STAFF REPORT
COMMUNITY DEVELOPMENT DEPARTMENT

HEARING DATE: January 5, 2023
 TO: Planning & Zoning Commission
 FROM: Stacy Hersh, Associate Planner
 208-884-5533
 SUBJECT: H-2022-0080 – TM Creek Apartments
 Phase 4 – CUP, ALT
 LOCATION: South of W. Franklin Rd. and east of S.
 Ten Mile Rd., in the NE ¼ of Section 14,
 Township 3N., Range 1W. (Parcel
 #S1214212630)

B. Site Plan (date: 8/1/2022)

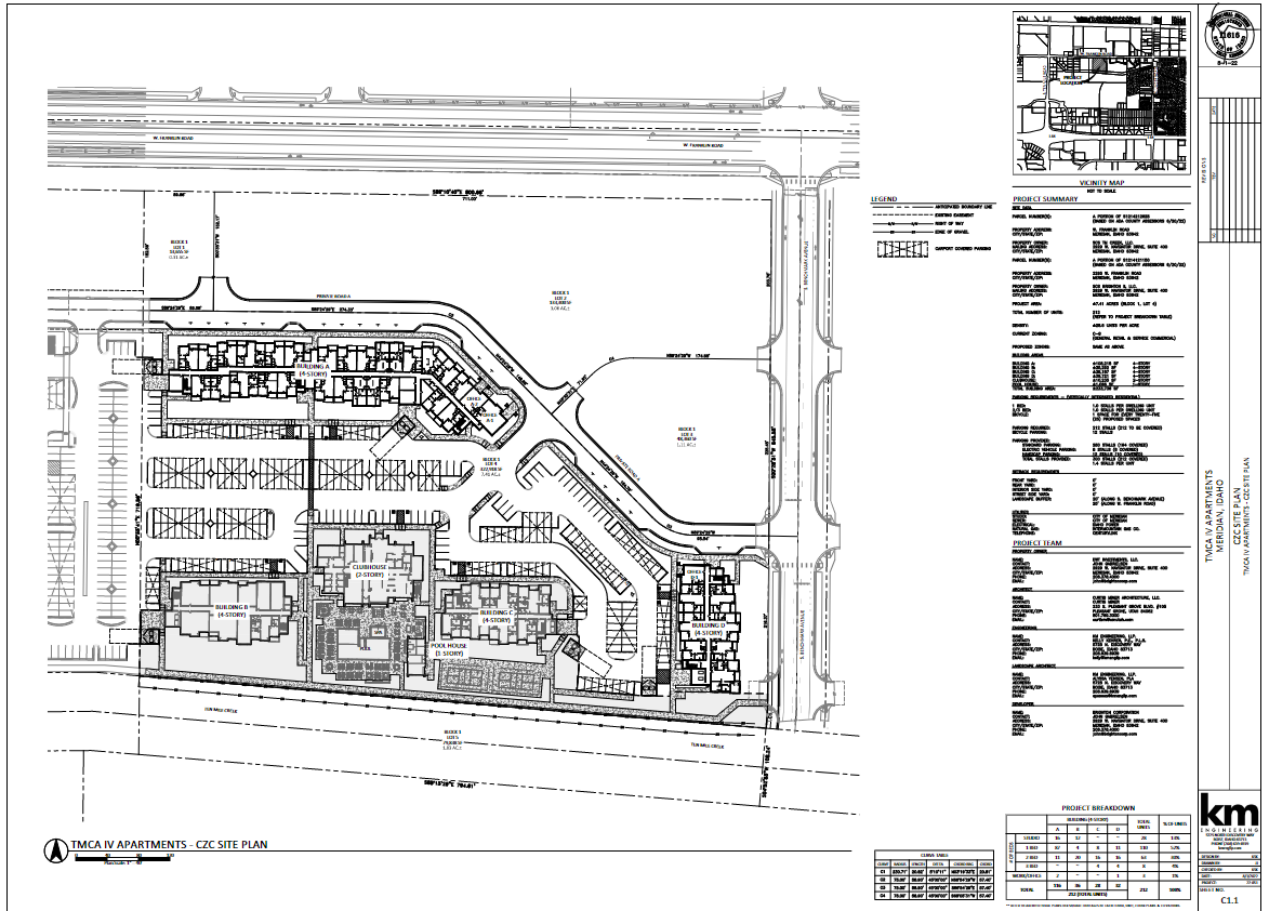
A total of 19,800 square feet of common open space is required for the multi-family portion of the development. The submitted open space exhibit depicts approximately 1.55 acres of common open space between this development and the vertically integrated portion of the development that was approved administratively with A-2021-0168. To ensure the multi-family portion of the

development meets the minimum open space standards, Staff recommends the Applicant submit a revised open space exhibit that only includes the boundary of the 2.36-acre multi-family development.

2. Common open space shall be not less than four hundred (400) square feet in area, and shall have a minimum length and width dimension of twenty feet (20'). *The common open space areas depicted on the open space exhibit in Section VIII.D meet this requirement.*

4. The site and/or landscape plan submitted with the Certificate of Zoning Compliance shall be revised as follows:
 - a. Depict the locations of the property management office, maintenance storage area, central mailbox location (including provisions for parcel mail, that provide safe pedestrian and/or vehicular access), and a directory and map of the development at an entrance or convenient location for those entering the development in accord with UDC 11-4-3-27B.7.

- b. All transformer and utility vaults and other service areas shall be located in an area not visible from a public street, or shall be fully screened from view from a public street in accord with UDC 11-4-3-27B.2.

- c. Depict landscaping along the pathway adjacent to the southern boundary of the site per the standards listed in UDC 11-3B-12C, which require a *mix* of trees, shrubs, lawn and/or other vegetative groundcover.

- e. The applicant shall submit a revised open space exhibit that only includes the boundary of the 2.36-acre multi-family development that demonstrates compliance with the common open space standards in UDC 11-4-3-27.

EXTERIOR ELEVATIONS

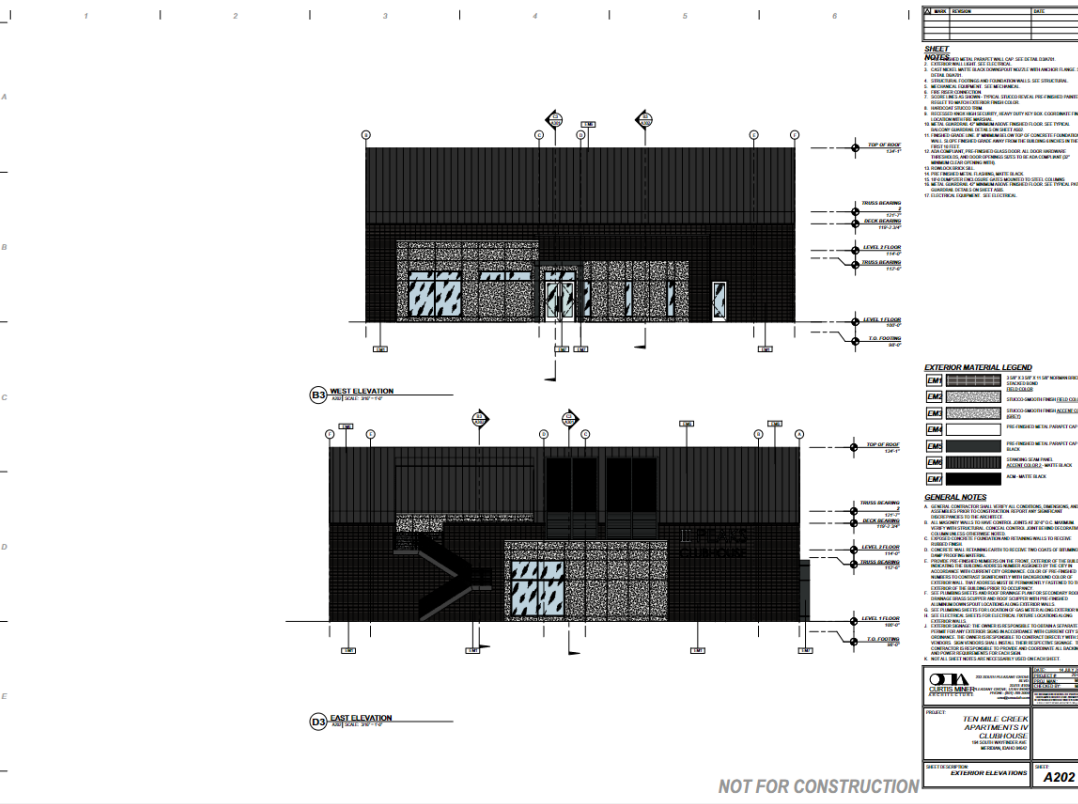
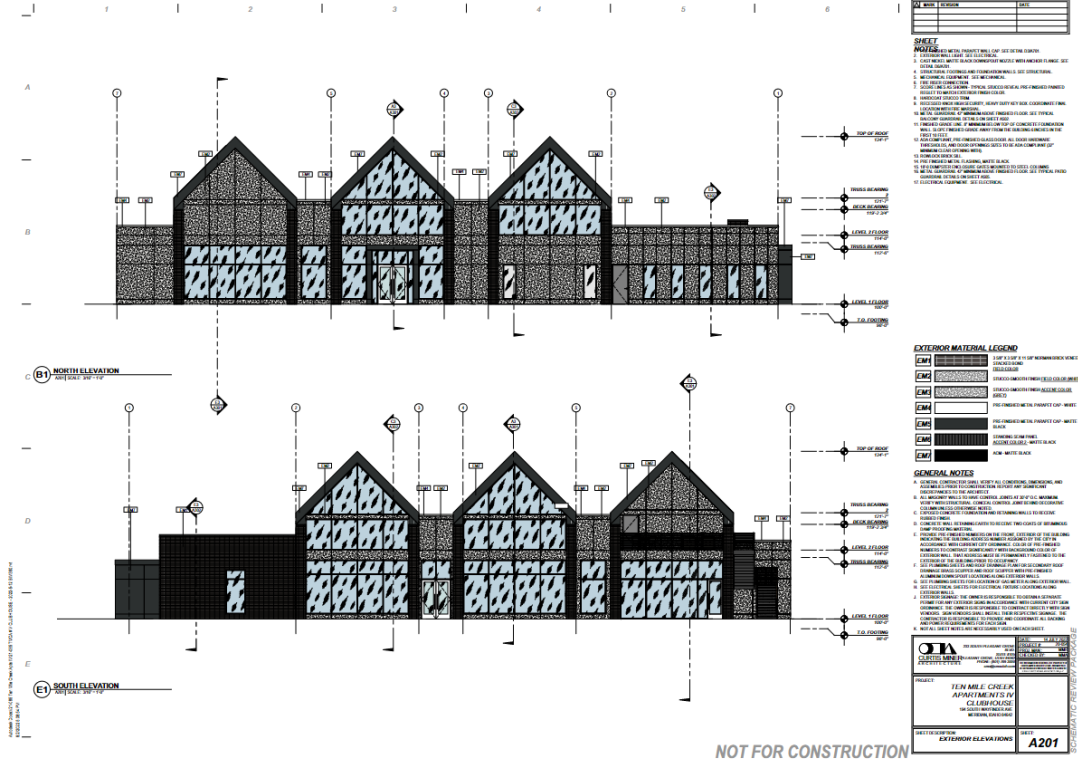
Conceptual building elevations were submitted for the proposed 4-story structures as shown in Section VIII.E. Building materials consist of stucco and bricks in neutral colors. Final design is required to comply with the adopted TM Crossing Design Guidelines.

A Certificate of Zoning Compliance application shall be submitted and compliance with the TM Crossing design guidelines is required as set forth in the DA prior to submittal of building permit applications.

9. An application for Certificate of Zoning Compliance shall be submitted for the proposed project and approved prior to submittal of building permit applications. Compliance with the design guidelines in the Ten Mile Interchange Specific Area Plan and the design standards listed in the Architectural Standards Manual as applicable is required.
